STATE OF VERMONT AGENCY OF TRANSPORTATION

PROPOSED IMPROVEMENT BRIDGE PROJECT TOWN OF HARTLAND COUNTY OF WINDSOR

RECORD PLANS	
CONTRACTOR:	KUBRICKY CONSTRUCTION CORP. - WILTON, NY
RESIDENT ENGINEER:	DARYL BASSETT
CONSTRUCTION BEGAN:	JUNE 10, 2014
CONSTRUCTION COMPLETE:	NOVEMBER 5, 2014
RECORD PLANS BY:	DARYL BASSETT & KEVIN KING
I HEREBY CERTIFY THAT ALL THE CONSTRUCTION REQUIRED BY THIS SET OF DRAWINGS HAS BEEN ACCOMPLISHED AS INDICATED HEREIN.	
BY	RESIDENT ENGINEER
DATE	2/22/16
NOTE: Any further information concerning final quantities, amounts or other details relative to this project may be found by contacting Vtrans Records Management.

US ROUTE 5 (MAJOR COLLECTOR), BRIDGE NUMBERS 62A AND 66

**WINGWALL TYPICAL SECTION**  
SCALE 3/4" = 1'-0"

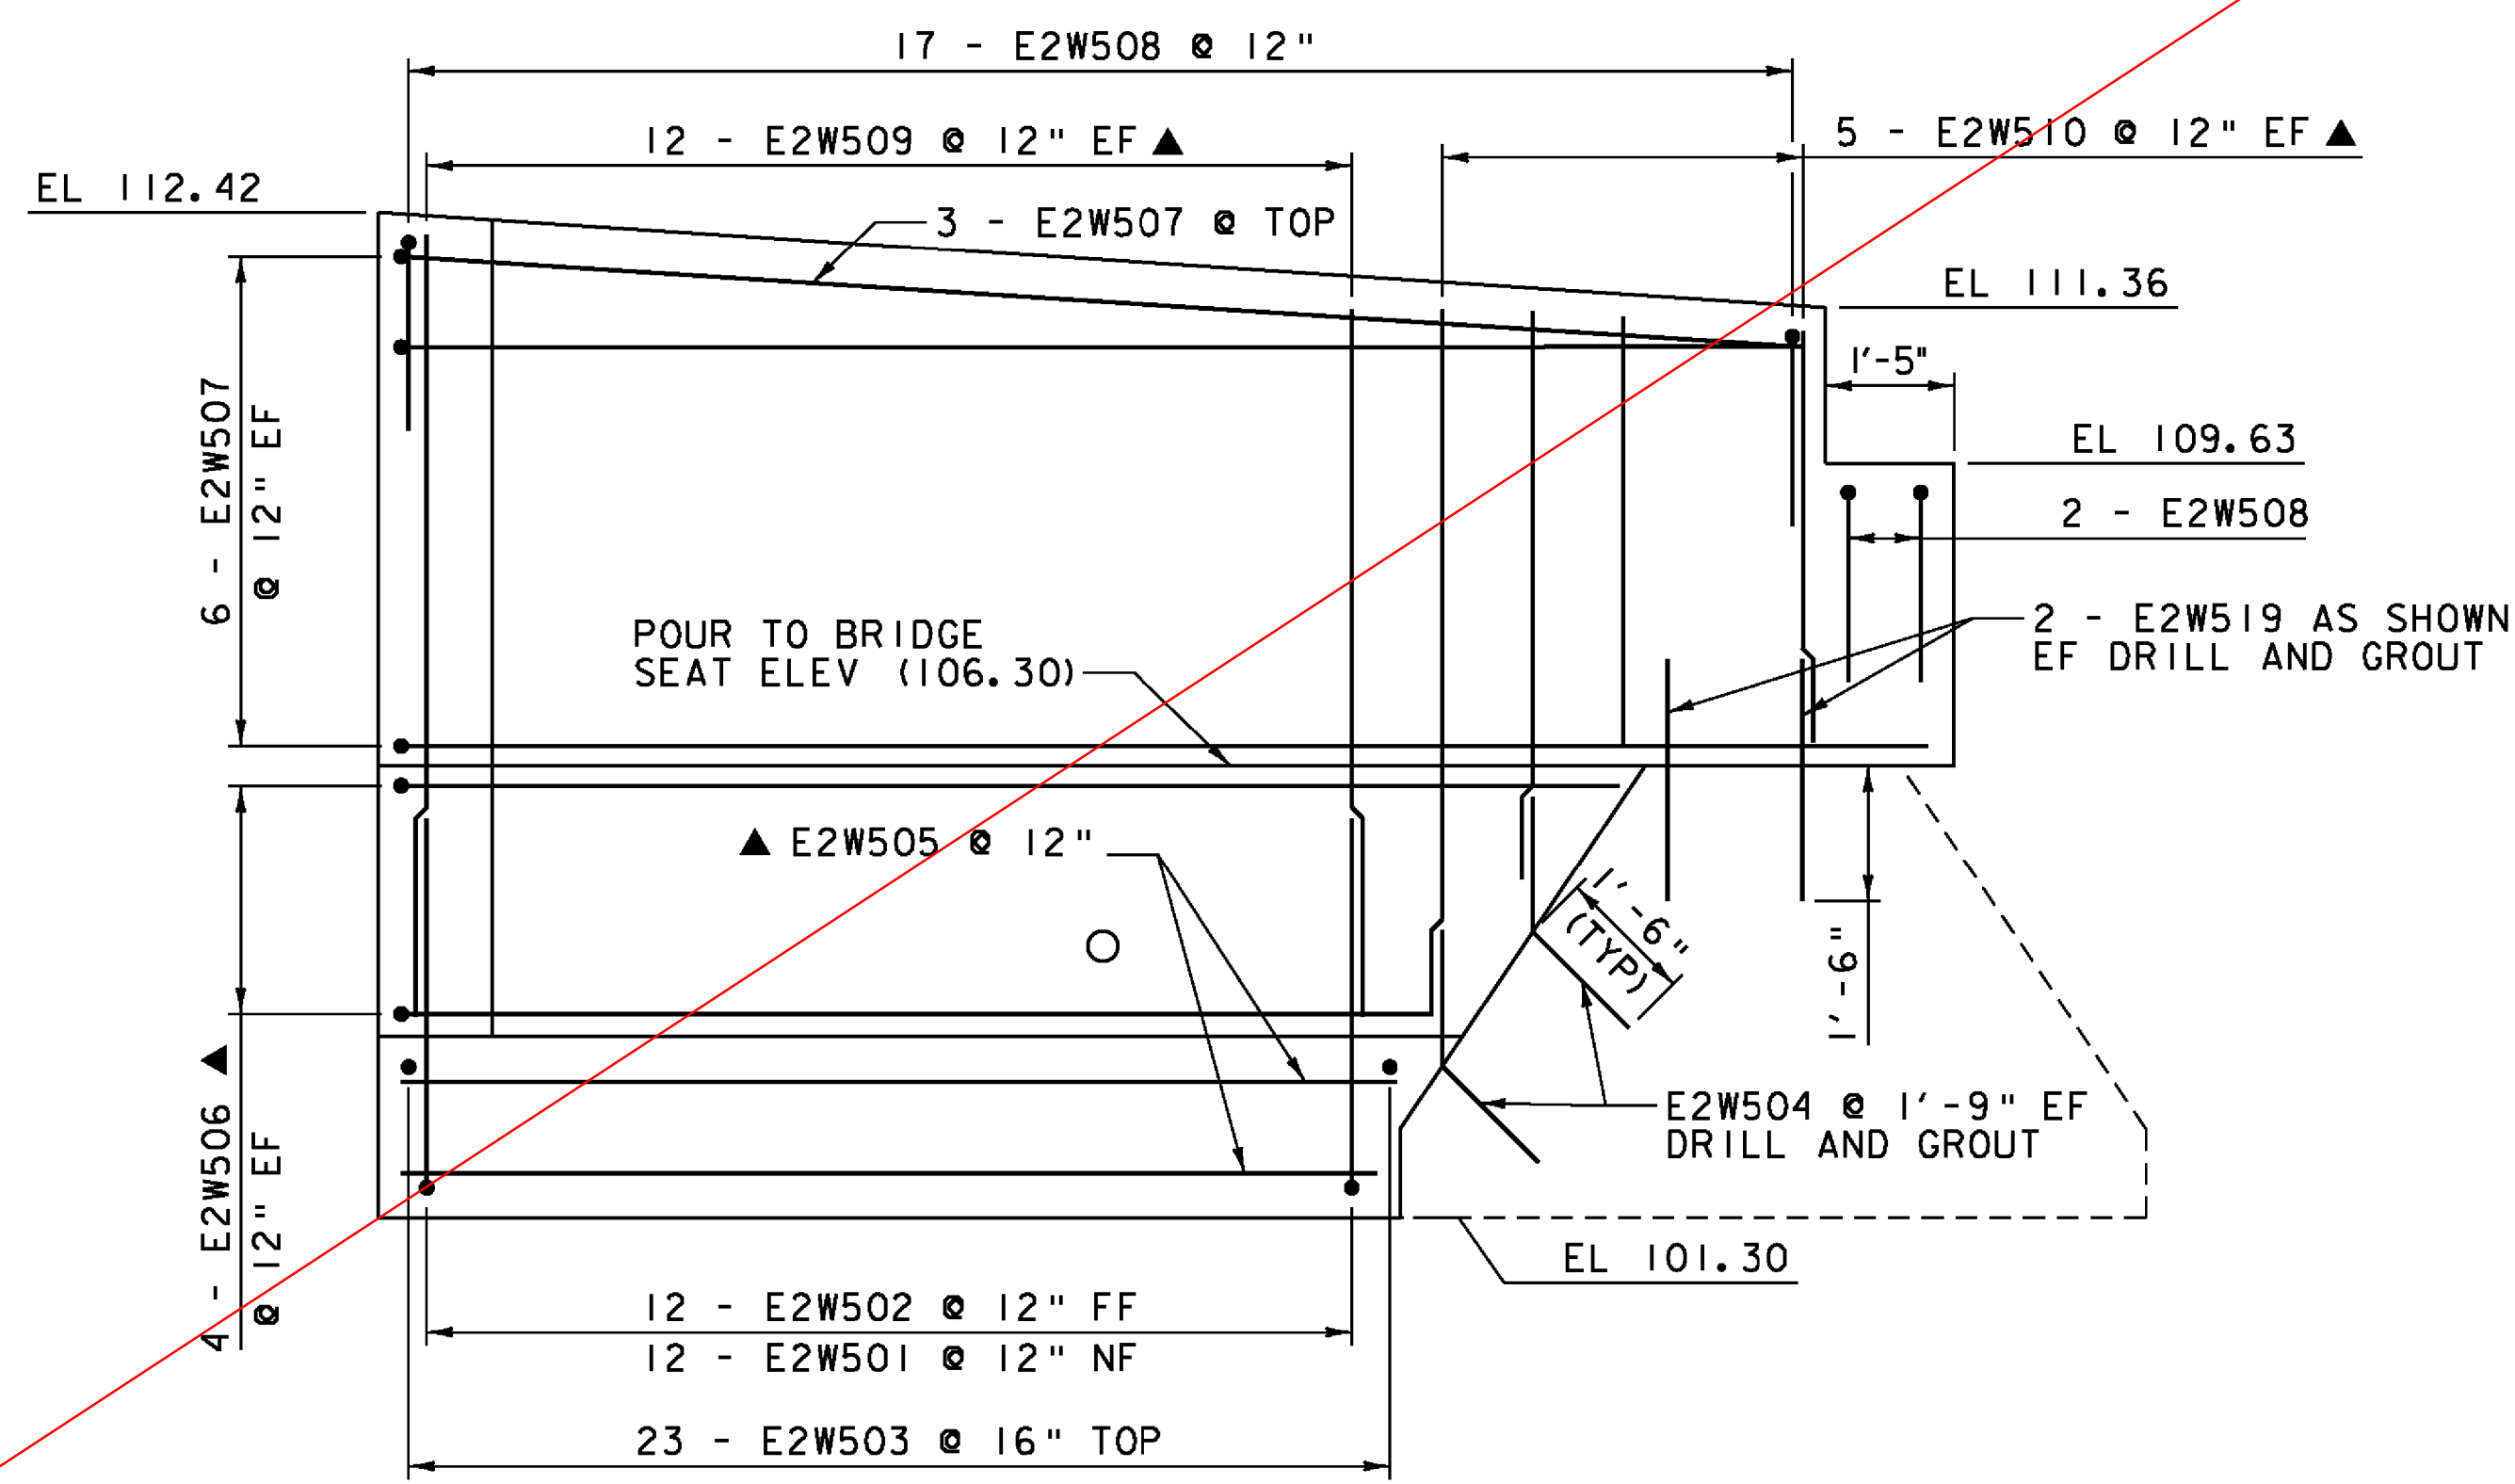
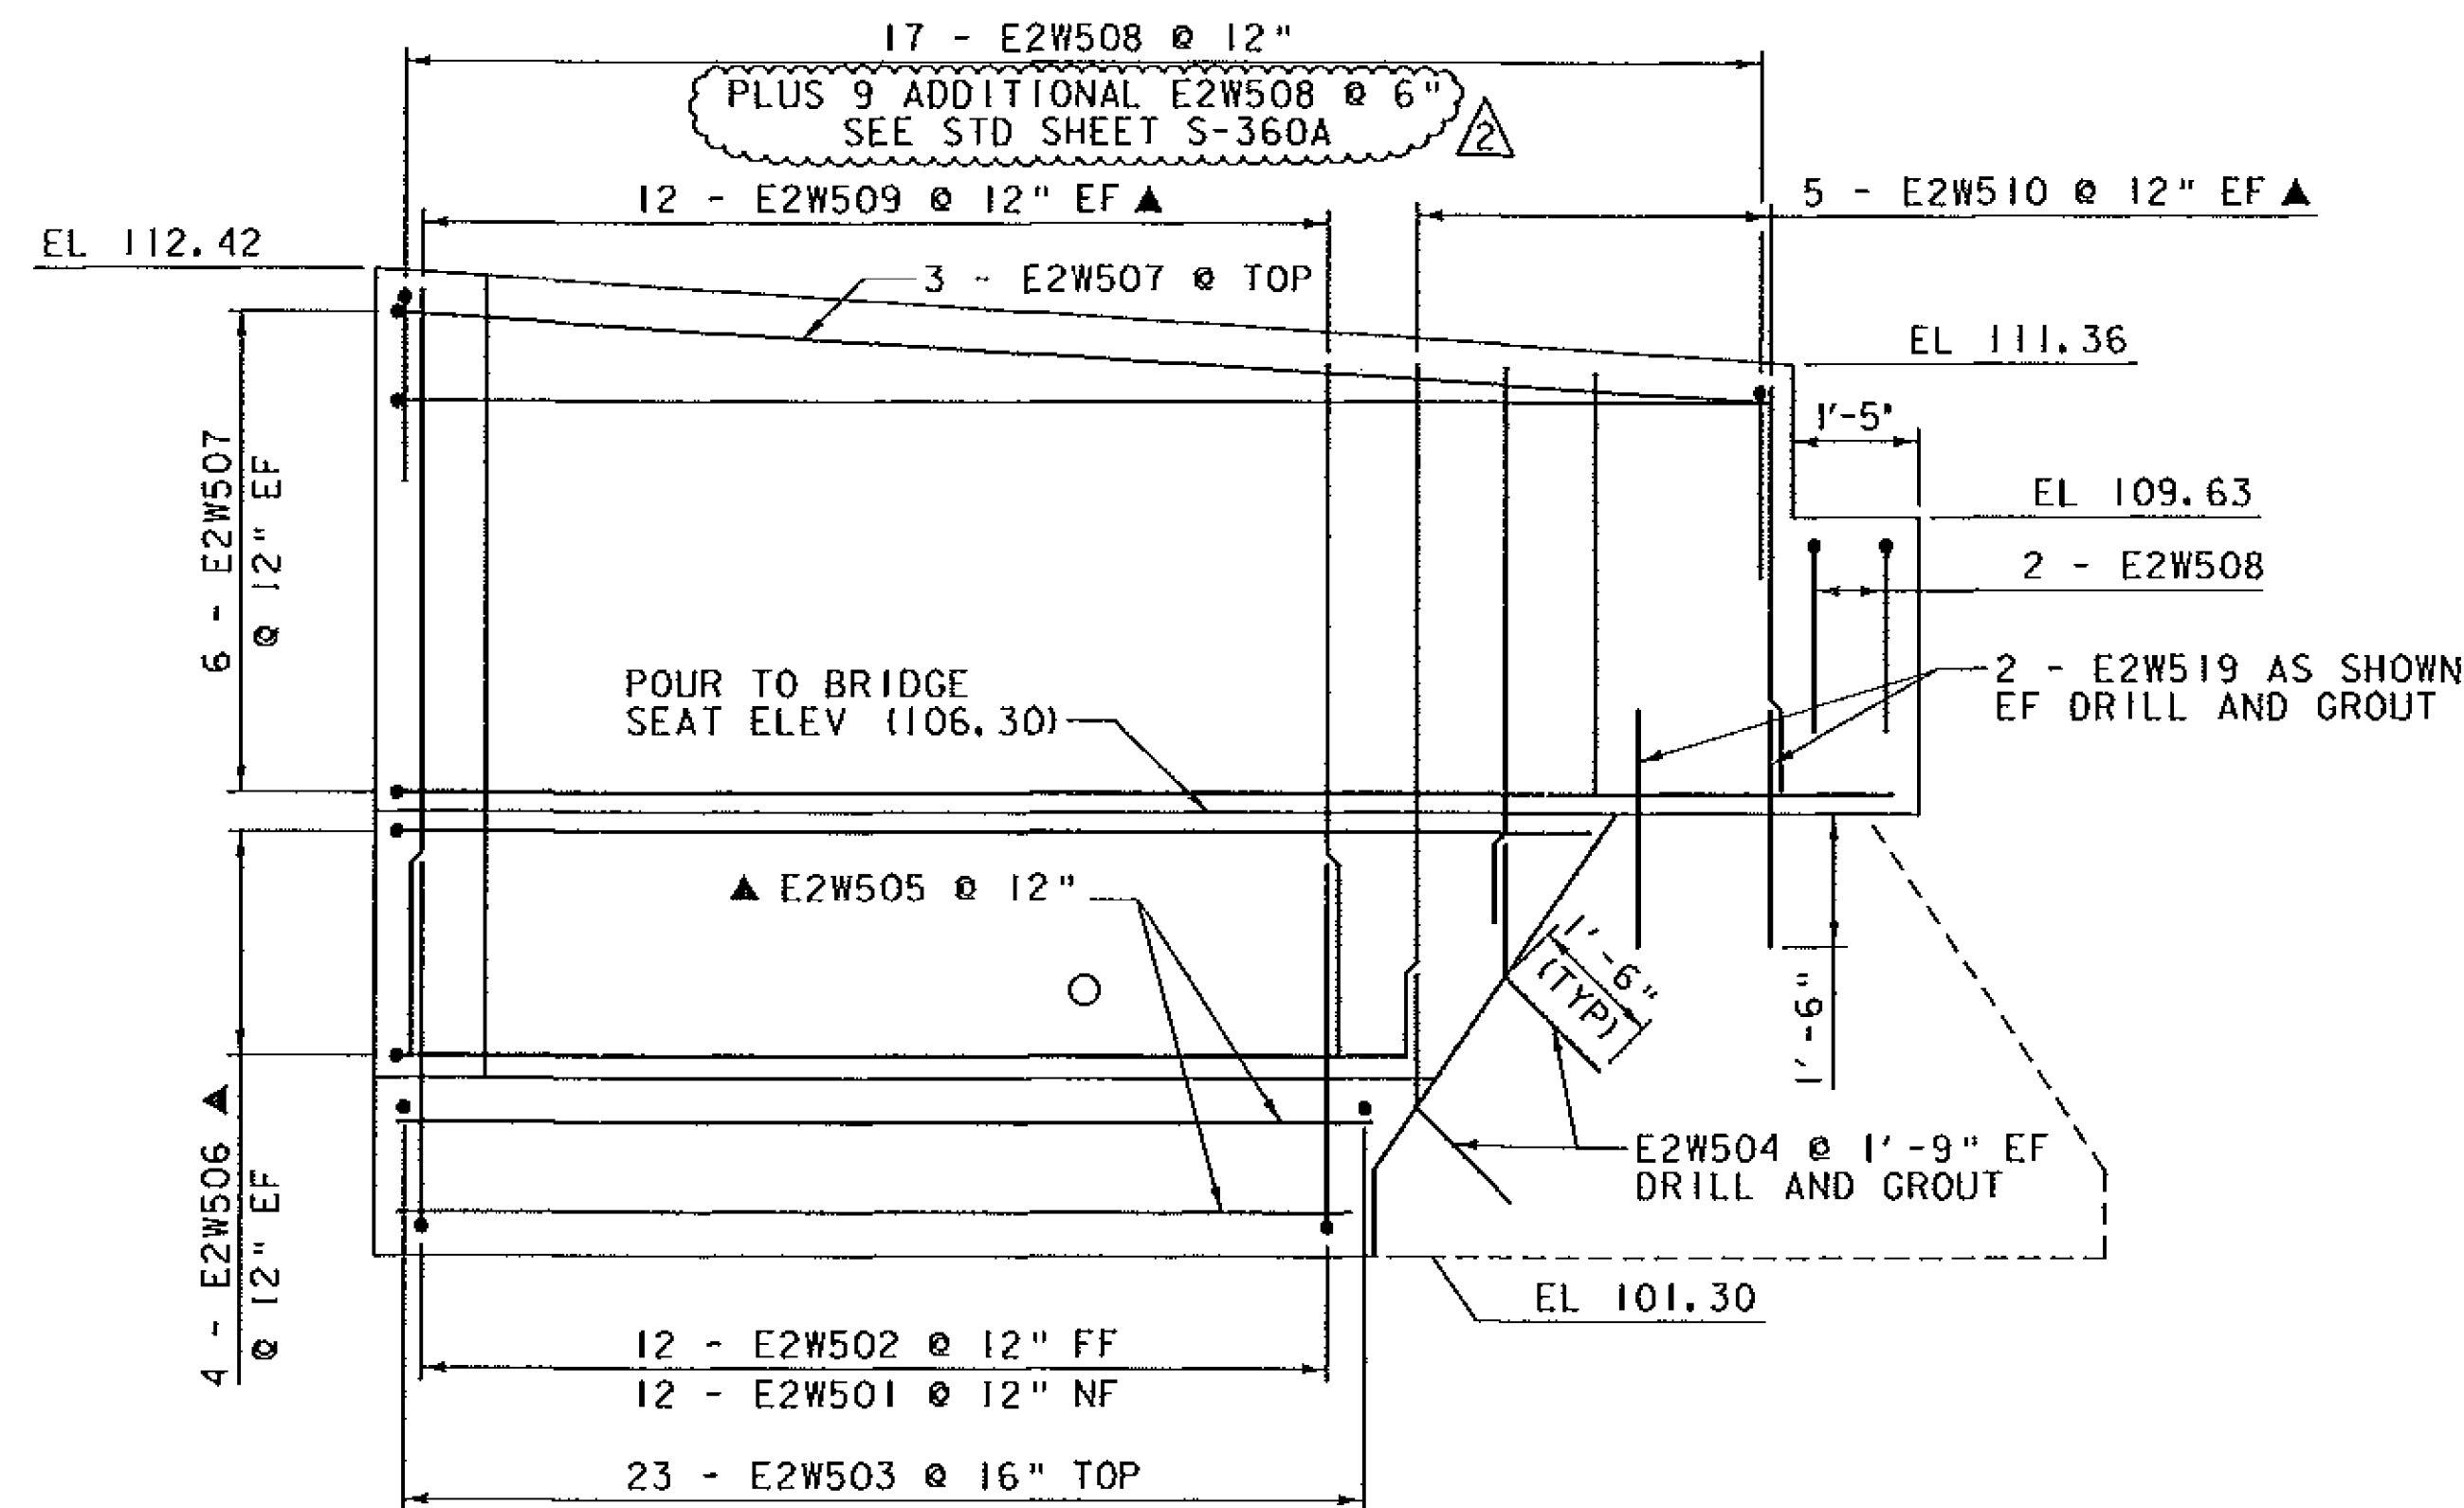
REV.	DESCRIPTION	DATE
△	ADDITIONAL EW508 AT POSTS	3/3/2014
PROJECT NAME: HARTLAND		
PROJECT NUMBER: BHF BPNT(12)		
FILE NAME: z:\c260sub.dgn		PLOT DATE: 3/3/2014
PROJECT LEADER: M.A. COLGAN		DRAWN BY: A.J. GOUDREAU
DESIGNED BY: A.J. GOUDREAU		CHECKED BY: S.G. FARNSWORTH
BR 62A WINGWALL DETAILS (1 OF 2)		SHEET 28 OF 55
